SR-2 – ADVISORY STAFF REPORT (04-03-2026)

ADDRESS: 4612 WOODWARD AVENUE

APPLICATION NUMBER: HDC2026-00100

*Right photo: taken by
Staff on 04/01/2026*

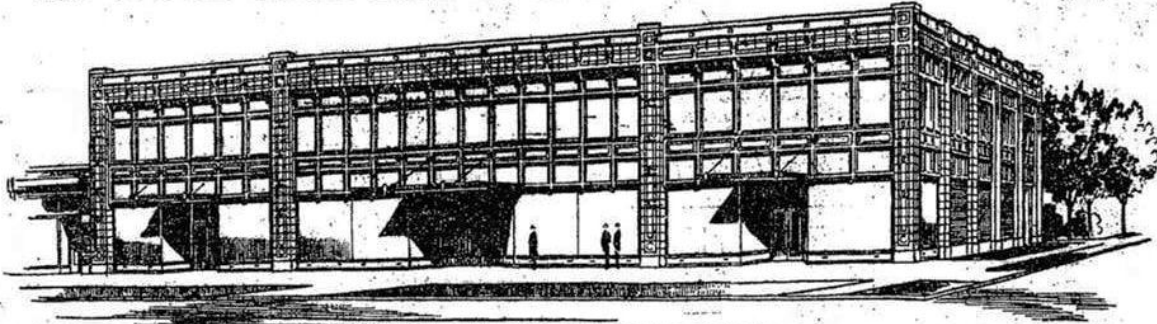
1. Both the installation of the black vinyl screens inside the storefront windows and the installation of the 'AutoZone' advertisements to the outside of the windows will alter the storefronts and their features. This will consequently diminish the historic character of the building.

- Both the installation of the black vinyl screens inside the storefront windows and the installation of the ‘AutoZone’ advertisements to the outside of the windows will alter the storefronts and their features. This will consequently diminish the historic character of the building.

- Therefore, it is staff’s opinion that the black vinyl screens will not be an appropriate alteration to the storefronts. Advertising copy inside the display windows, and not adhered to the outside glass, would be compatible and appropriate for this occupancy and use.
